**GRAVITY SEWER 5
AT
LAKEWATCH PLANTATION**
PLANNED COMMERCIAL DEVELOPMENT
DEVELOPED BY: LAKE WATCH, L.L.C.
GILLS CREEK MAGISTERIAL DISTRICT
FRANKLIN COUNTY, VIRGINIA
JOB NO 21-04
NOVEMBER 20, 2008
REVISED DECEMBER 11, 2008

SHEET SHEET 4 OF 8

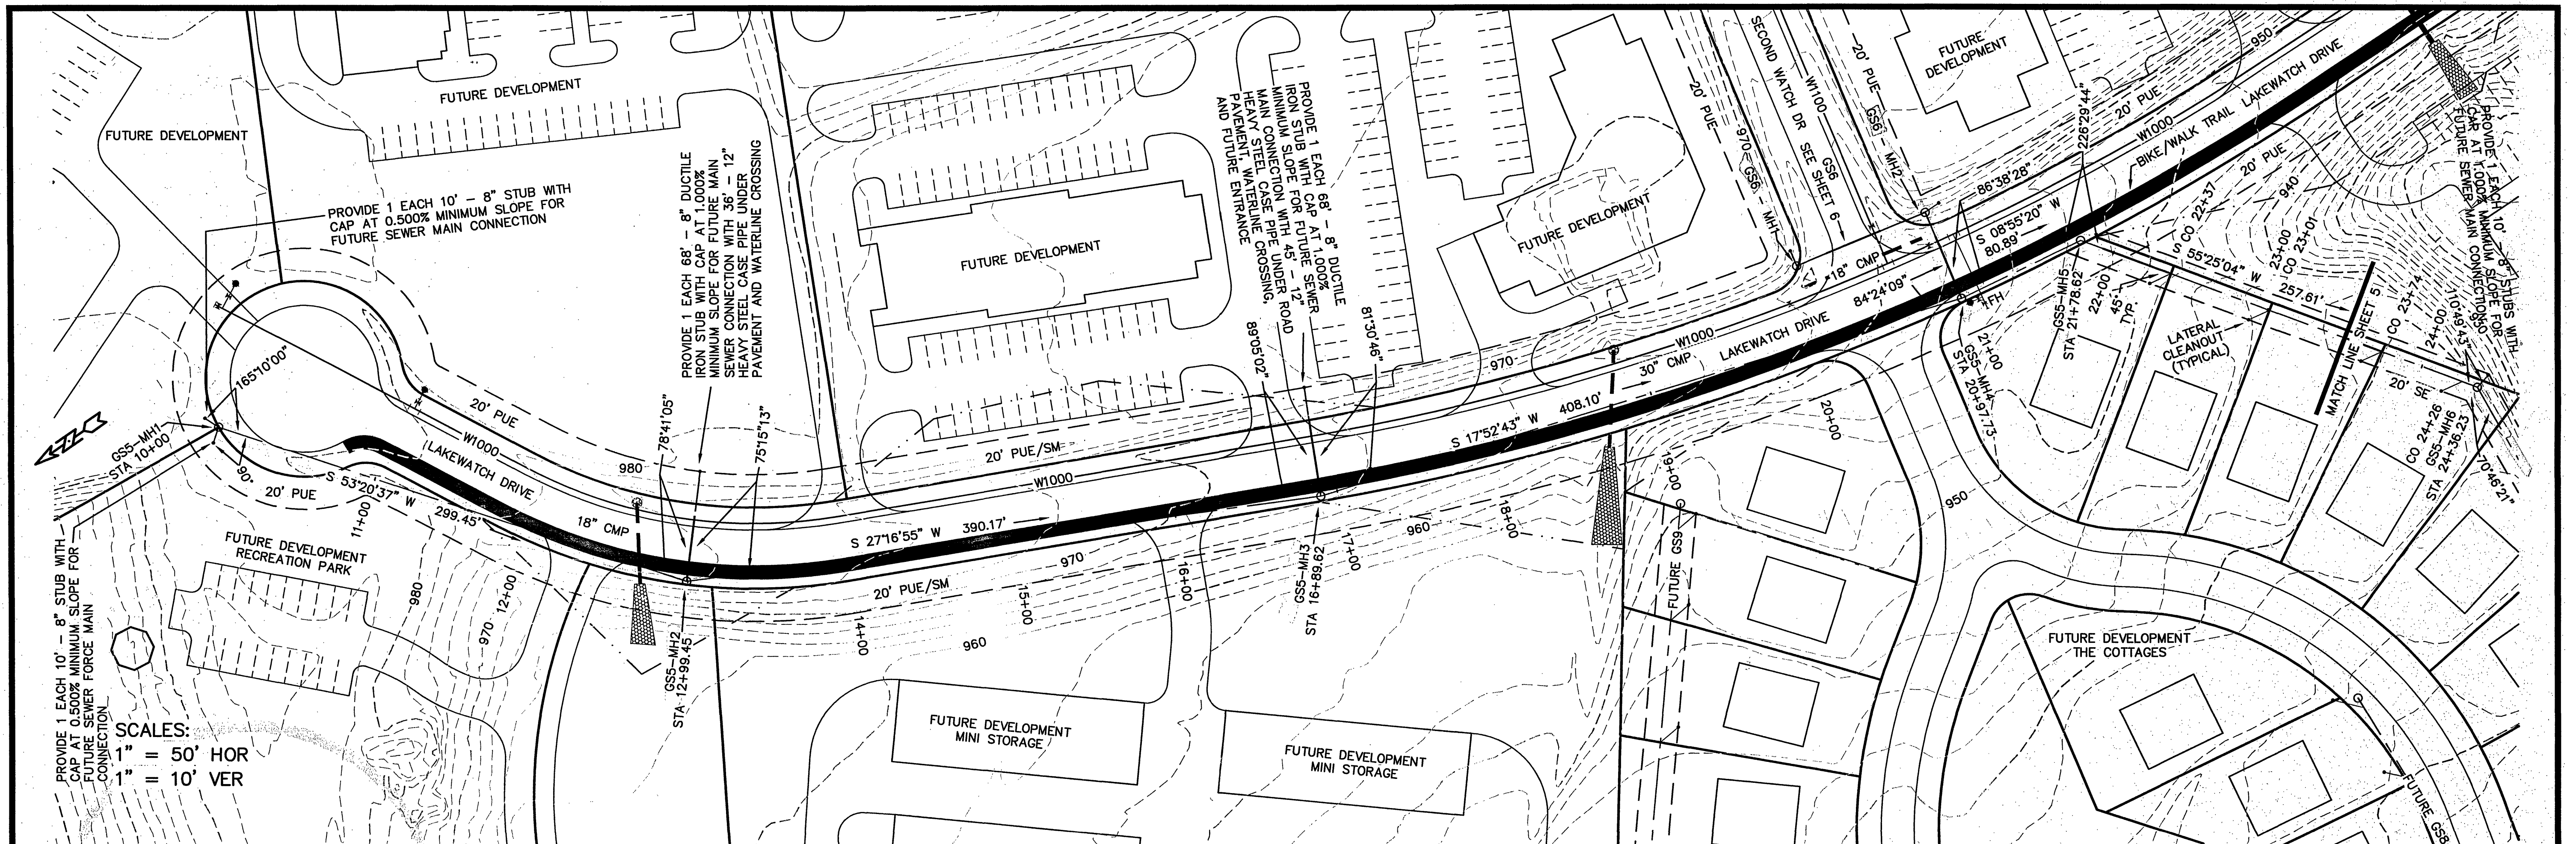
DECEMBER 11, 2008 REVISION:
ALL INDIVIDUAL SERVICE LATERALS REMOVED FROM PROPOSED MANHOLES.
CHANGE LABEL DESIGNATION FOR SEWER STUB WITH CAP AT MANHOLE GS5-MH1 TO CLARIFY THAT 8" STUB IS FOR FUTURE SEWER FORCE MAIN CONNECTION.
CHANGE LABEL DESIGNATION FOR SEWER STUB WITH CAP AT MANHOLE GS5-MH2, GS5-MH3, AND GS5-MH6 TO CLARIFY THAT 8" STUBS ARE FOR FUTURE SEWER MAIN CONNECTIONS.
